**SERVICE BULLETIN****N° 139-469****OPTIONAL****DATE:** May 26, 2017**REV. :** A - August 4, 2023

**TITLE****ATA 30 - PASSENGER CABIN DRAINAGES INSTALLATION****REVISION LOG**

This Service Bulletin is issued in order to provide all necessary instructions on how to perform the passenger cabin drainage installation P/N 3G3070A12711.

**Figure 1**

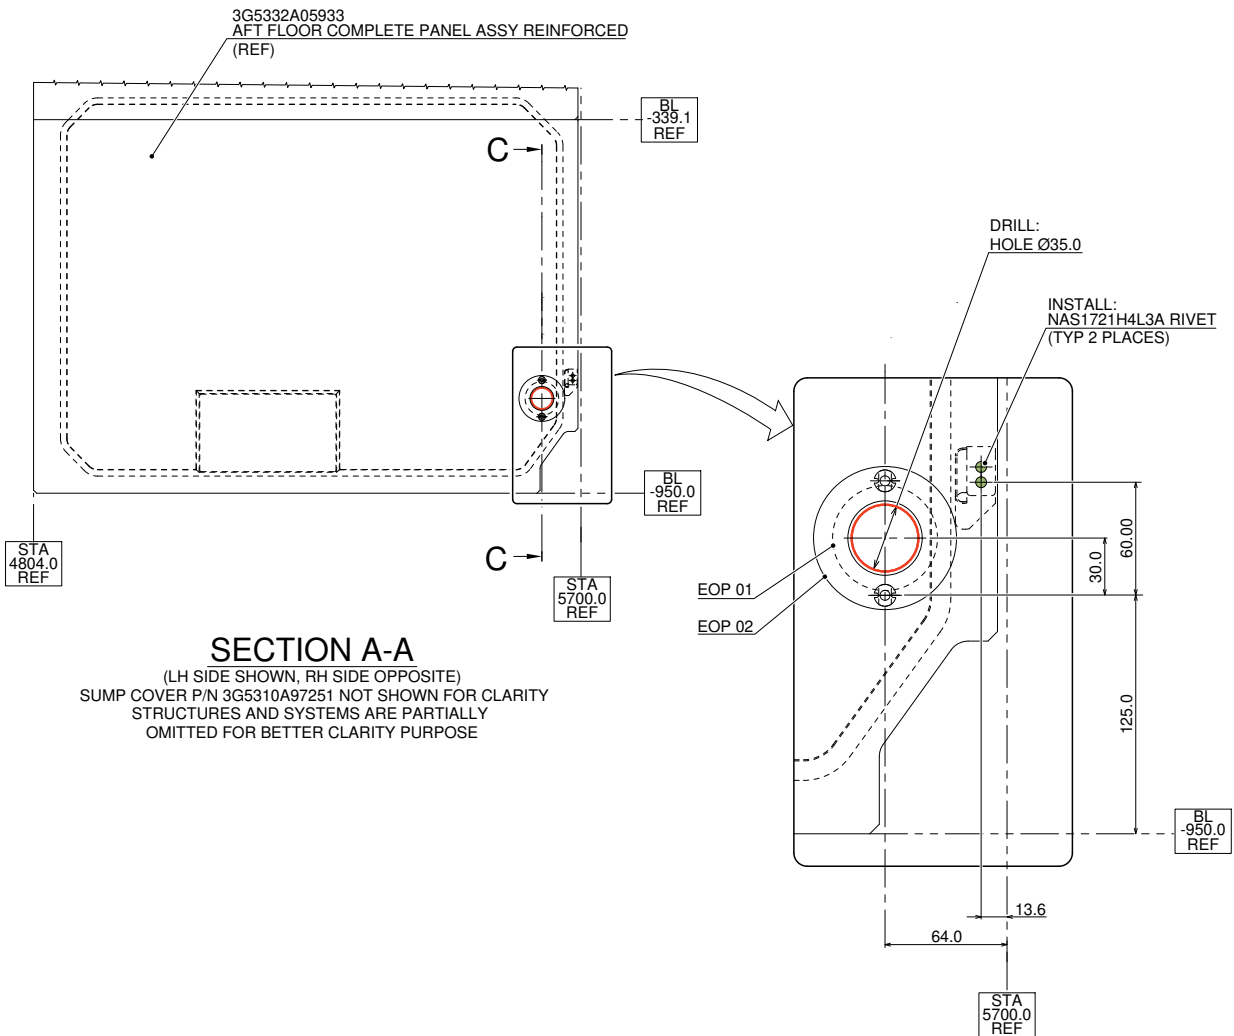
- 2.1 In accordance with AMP DM 39-A-53-23-03-00A-520A-K and with reference to Figure 1, remove the aft floor complete panel assy reinforced P/N 3G5332A05933 from the helicopter.

- 2.15 With reference to Figure 1 Section A-A, drill hole  $\varnothing 35.0$  thru aft floor complete panel assy reinforced P/N 3G5332A05933 in the indicated position; coordinate the hole position with the installed drainage pipe assy P/N 3G3070A13931.

**Figure 2**

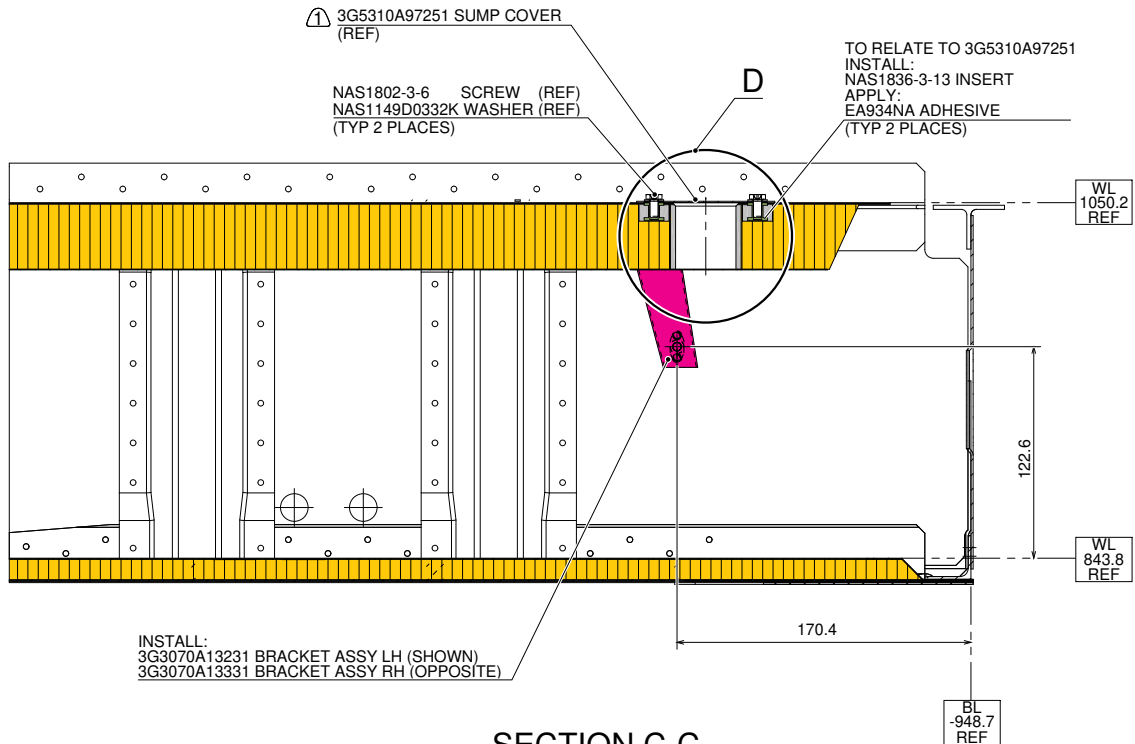
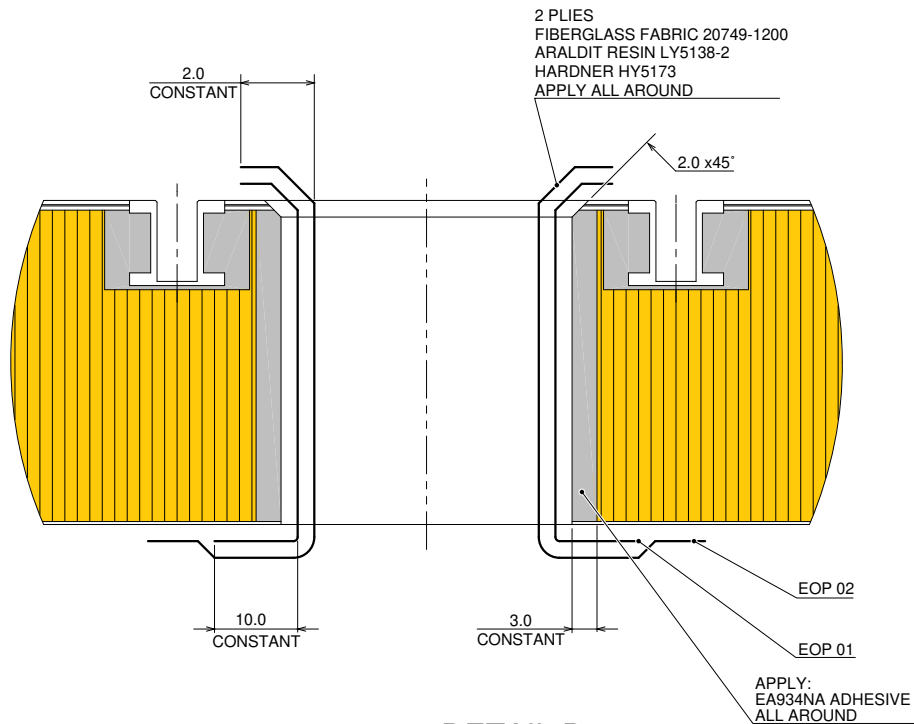
- 2.2 With reference to Figure 1 Section A-A and Figure 2 Section C-C, install the bracket assy LH P/N 3G3070A13231 in the indicated position by means of n°2 rivets P/N NAS1721H4L3A.

- 2.16 With reference to Figure 2 Detail D, chamfer 2mm x45° the upper hole edge.
- 2.17 With reference to Figure 2 Detail D, fill the honeycomb edge with adhesive EA934NA (C057).

- 2.18 Prepare a compound mixing 100 parts by weight of araldit resin LY5138-2 and 23 parts by weight of hardener HY5173.
- 2.19 With reference to Figure 2 Detail D, apply around the drilled hole n°2 plies of fiberglass fabric 20749-1200 (C931) soaked with the previously prepared compound. Let adhesive cure.

- 2.21 In accordance with CSRP DM CSRP-A-51-42-00-00A-720A-D and with reference to Figure 1 Section A-A and Figure 2 Section C-C, drill n°2 holes Ø 11.48÷11.60 in the previously countermarked positions and install n°2 inserts P/N NAS1836-3-13 by means of adhesive EA934NA (C057).

**Figure 3**

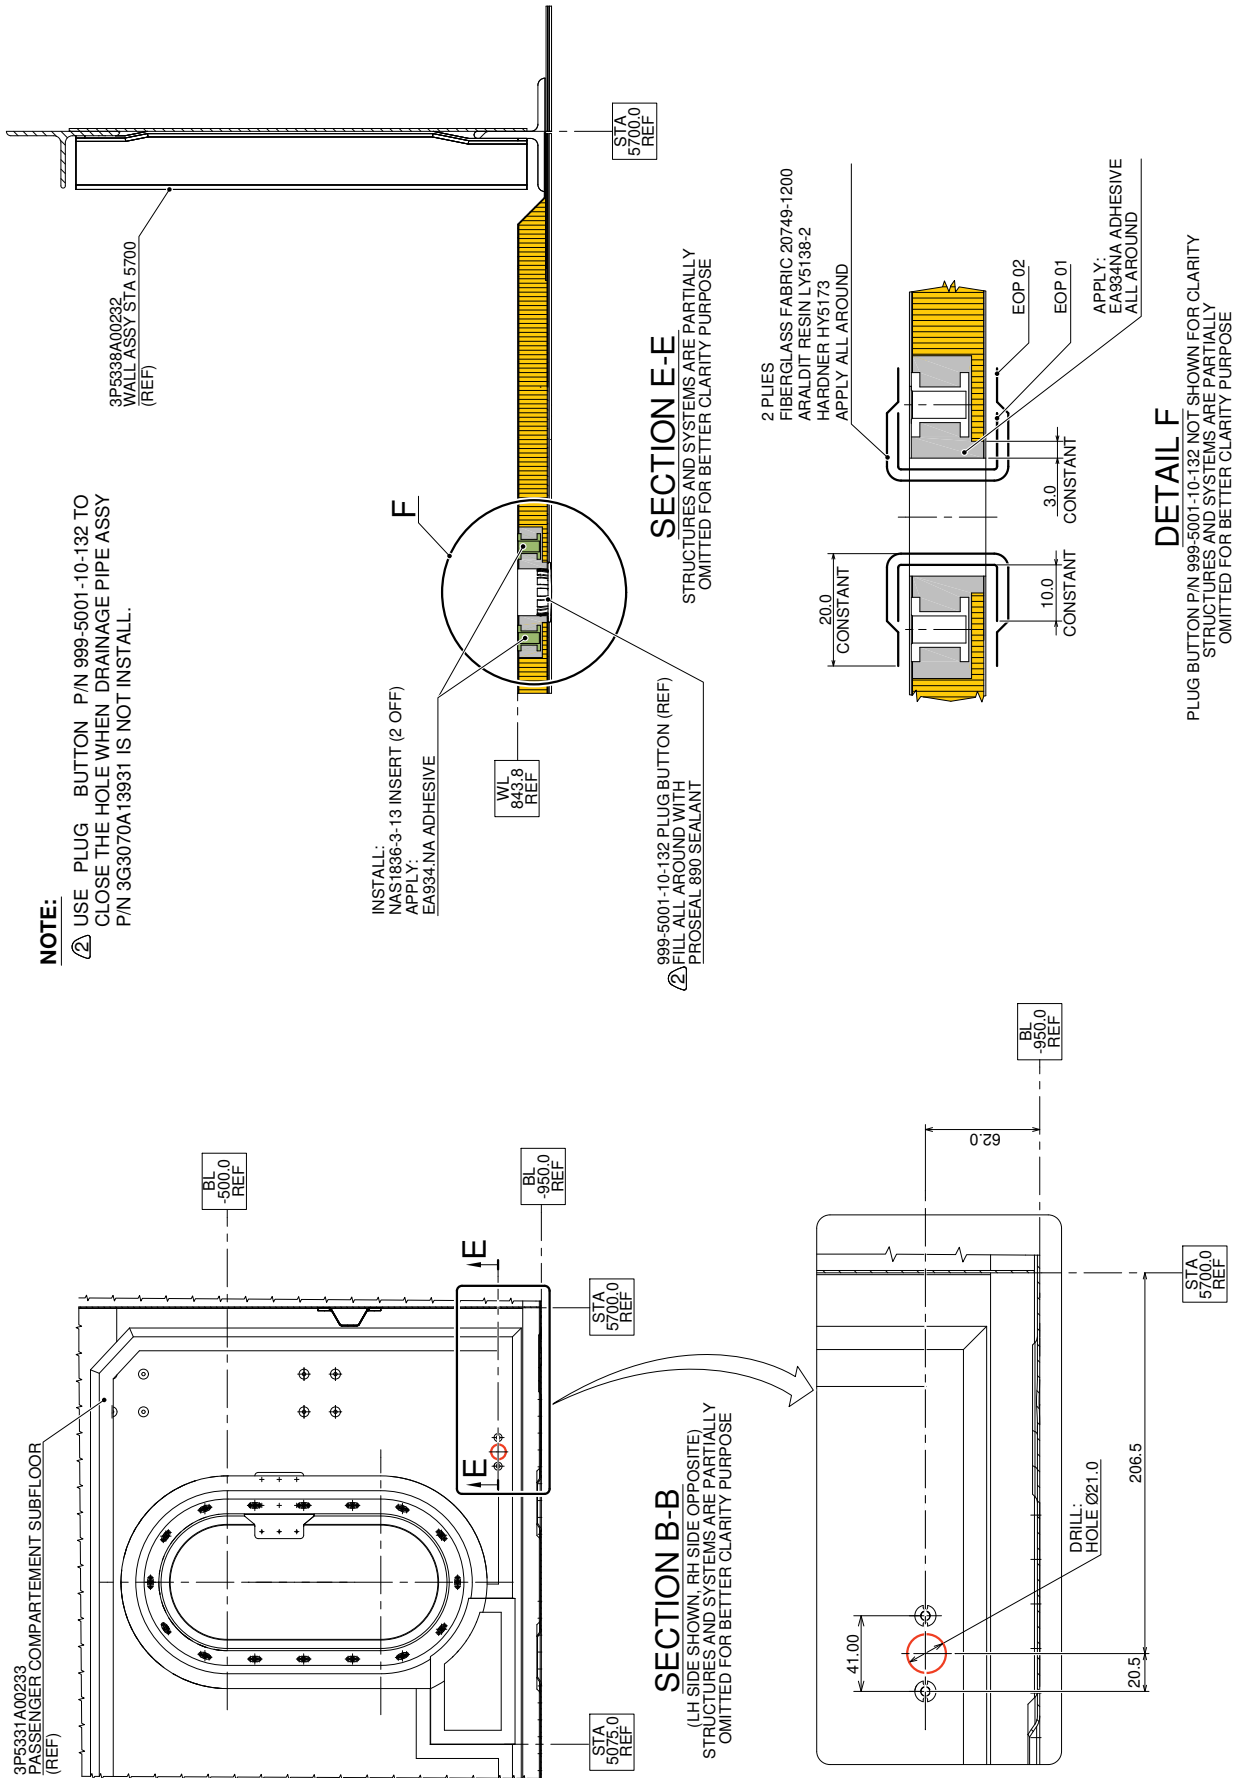
- 2.4 With reference to Figure 3 Section B-B, mark the position of the hole to drill on the passenger compartment subfloor, coordinating with the drainage pipe assy position.

- 2.5 Remove the drainage pipe assy P/N 3G3070A13931 and relevant hardware from the helicopter.
- 2.6 With reference to Figure 3 Section B-B, drill hole  $\varnothing 21.0$  thru the passenger compartment subfloor in the previously marked position.

- 2.7 With reference to Figure 3 Detail F, fill the honeycomb edge with adhesive EA934NA (C057).
- 2.8 Prepare a compound mixing 100 parts by weight of araldit resin LY5138-2 and 23 parts by weight of hardener HY5173.

- 2.9 With reference to Figure 3 Detail F, apply around the drilled hole n°2 plies of fiberglass fabric 20749-1200 (C931) soaked with the previously prepared compound. Let adhesive cure.

- 2.10 With reference to Figure 3 Section B-B, temporarily re-install the drainage pipe assy P/N 3G3070A13931 (Ref. step 2.3) and countermark on the passenger subfloor panel the positions of the n°2 insert holes to drill.

- 2.11 Remove the drainage pipe assy P/N 3G3070A13931 and relevant hardware from the helicopter.
- 2.12 In accordance with CSRP DM CSRP-A-51-42-00-00A-720A-D and with reference to Figure 3 Section B-B and Section E-E, drill n°2 holes  $\varnothing 11.48 \div 11.60$  in the previously countermarked positions and install n°2 inserts P/N NAS1836-3-13 by means of adhesive EA934NA (C057).

**Figure 4**

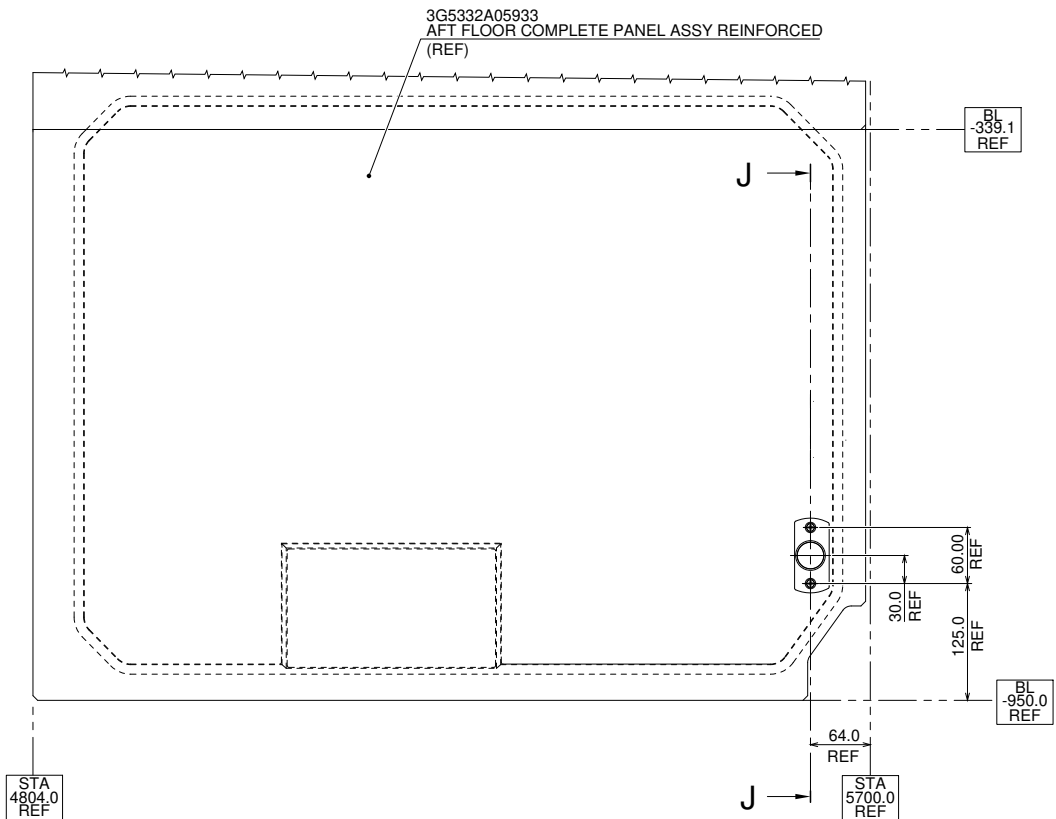
- 2.20 With reference to Figure 4 Section G-G and Figure 5 Section J-J, temporarily position the drain sump assy P/N 3G5310A96731 in its installation position; countermark on the panel the positions of the n°2 insert holes to drill.

**Figure 5**

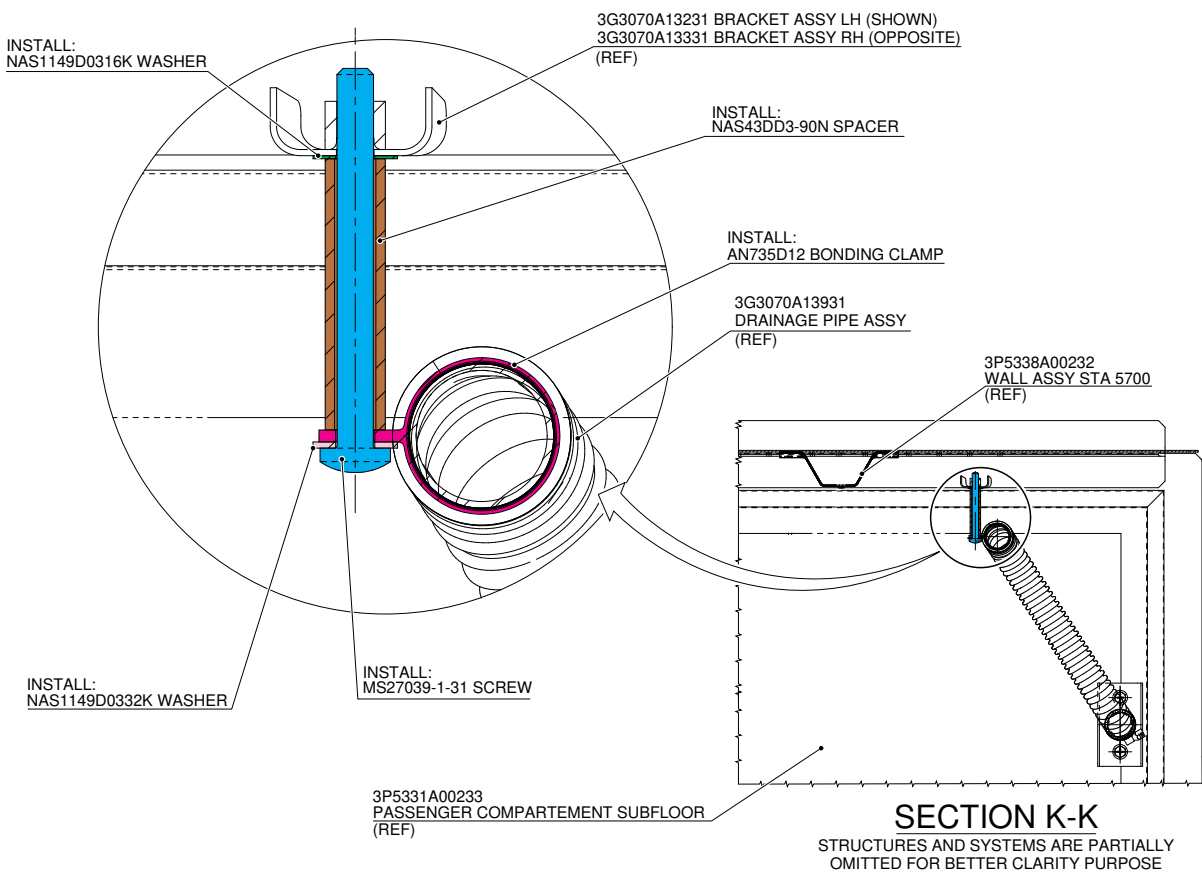
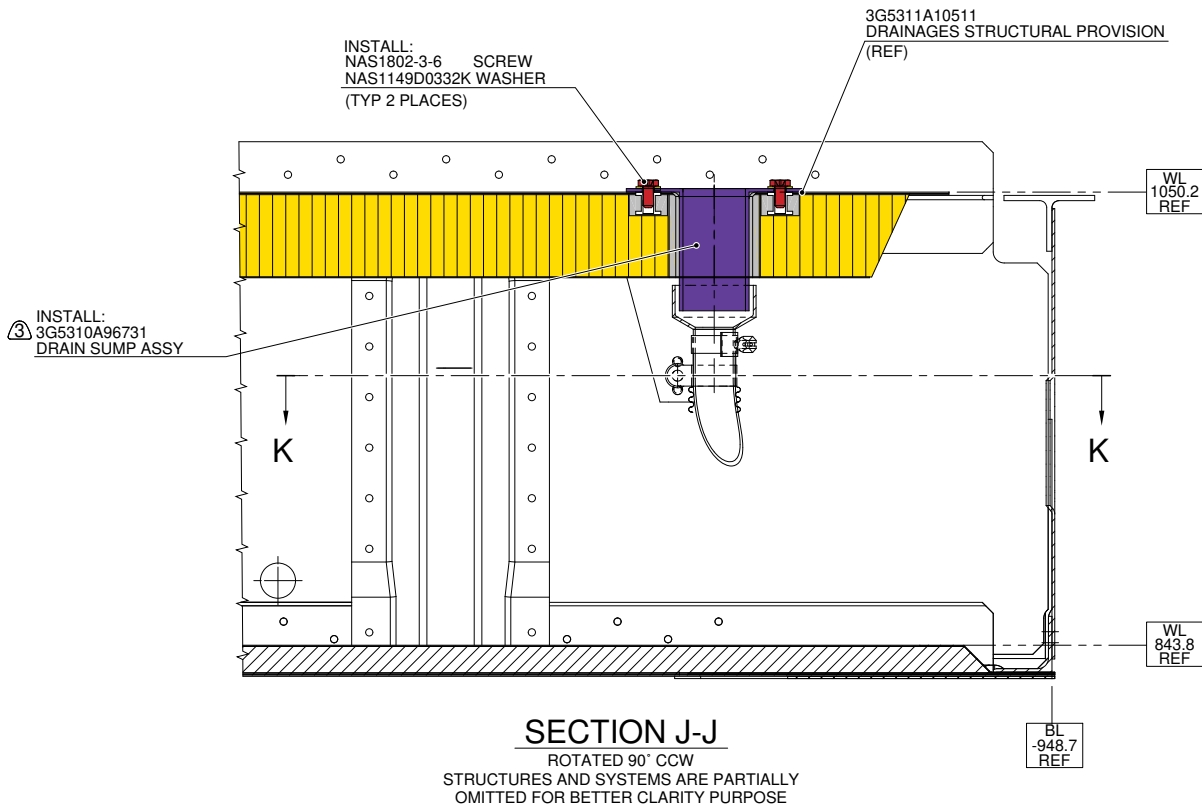
- 2.3 With reference to Figure 5 Section K-K, temporarily secure the drainage pipe assy P/N 3G3070A13931 to the bracket assy LH P/N 3G3070A13231 with a washer P/N NAS1149D0316K, a spacer P/N NAS43DD3-90N, a clamp P/N AN735D12, a washer P/N NAS1149D0332K and a screw P/N MS27039-1-31.

- 2.14 With reference to Figure 5 Section K-K, secure the drainage pipe assy P/N 3G3070A13931 to the bracket assy LH P/N 3G3070A13231 with a washer P/N NAS1149D0316K, a spacer P/N NAS43DD3-90N, a clamp P/N AN735D12, a washer P/N NAS1149D0332K and a screw P/N MS27039-1-31.

- 2.22 With reference to Figure 5 Section J-J, install the drain sump assy P/N 3G5310A96731 by means of n°2 washers P/N NAS1149D0332K and n°2 screws P/N NAS1802-3-6.

**Figure 6**

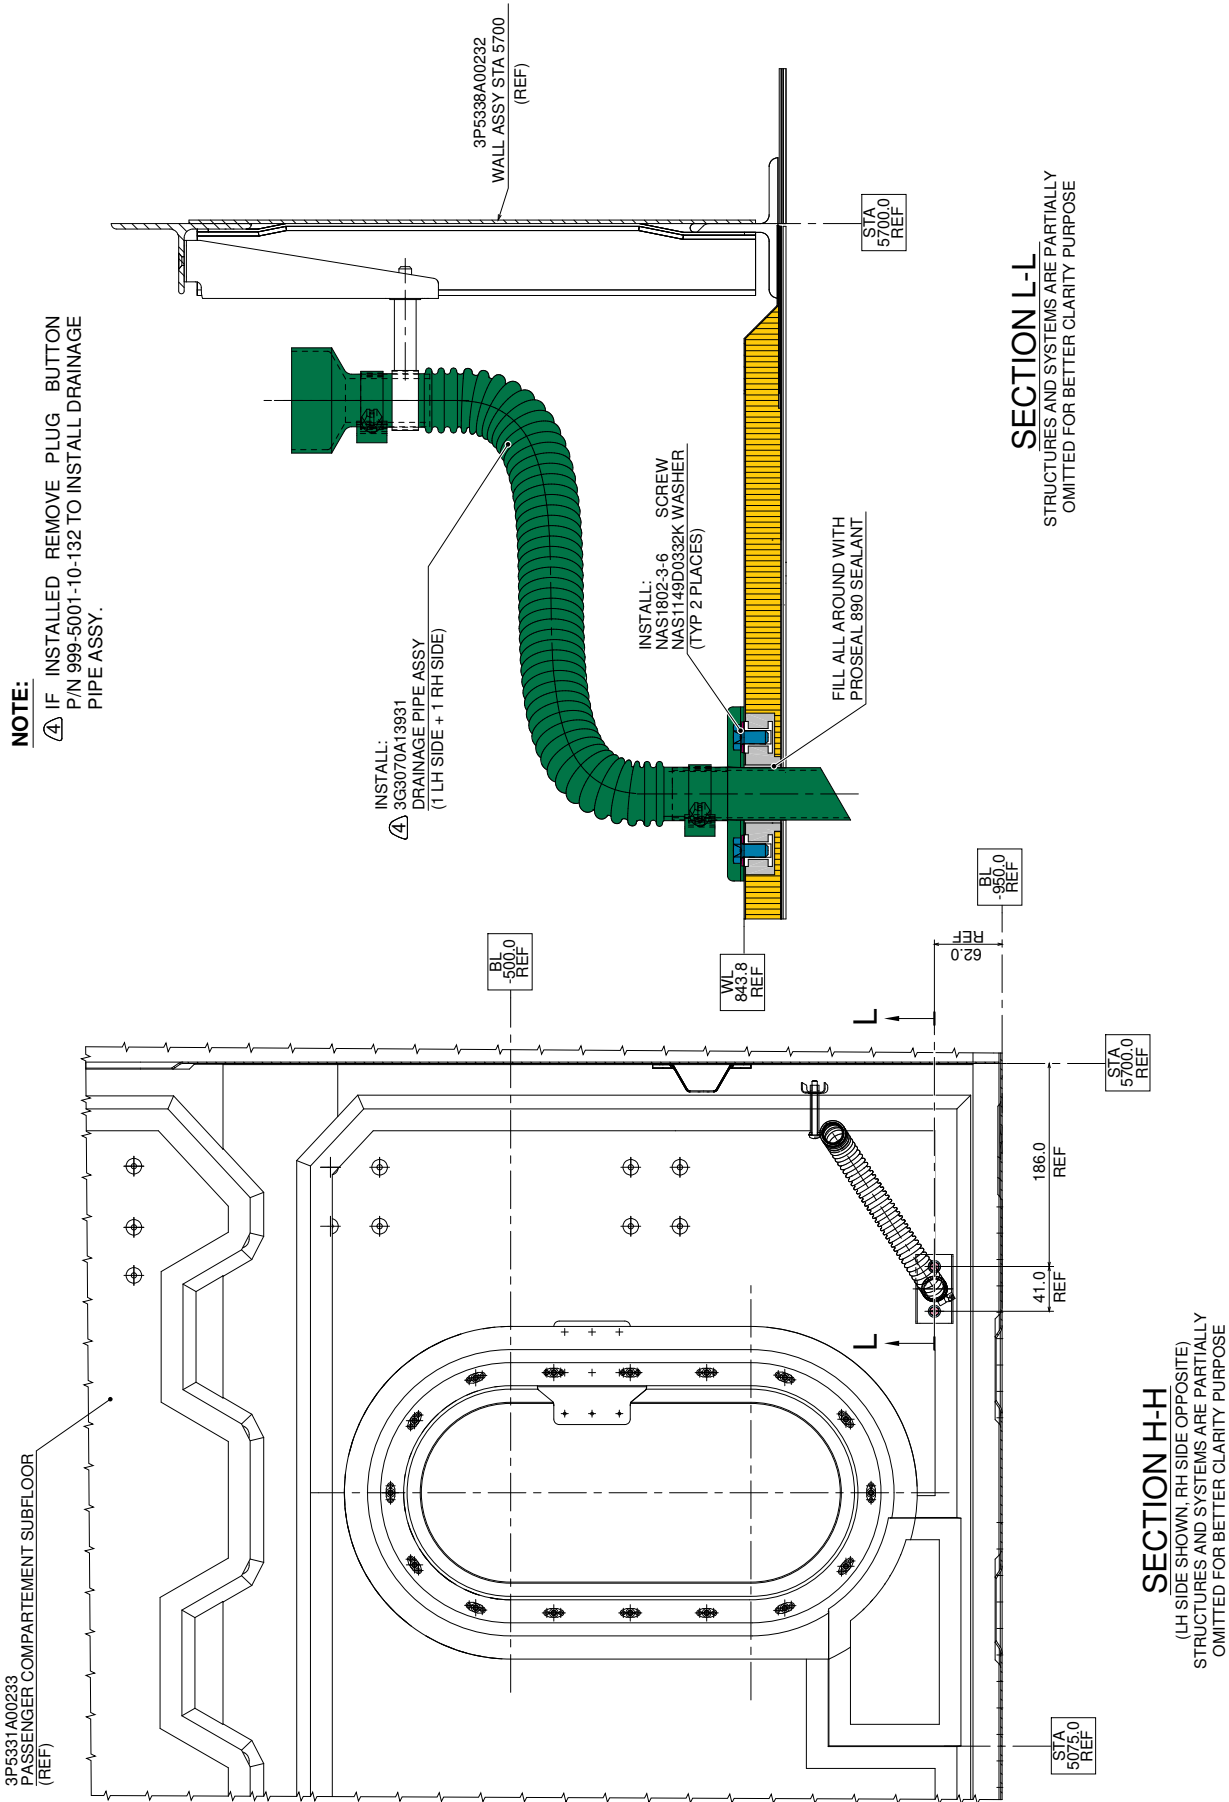
- 2.13 With reference to Figure 6 Section H-H, secure the drainage pipe assy P/N 3G3070A13931 to the passenger compartment subfloor by means of n°2 washers P/N NAS1149D0332K and n°2 screws P/N NAS1802-3-6.

- 2.23 With reference to Figure 6 Section L-L, seal the edge of the drainage pipe assy P/N 3G3070A13931 with sealant PROSEAL 890 (C153).
3. Perform step 2 again for RH side drainages installation.
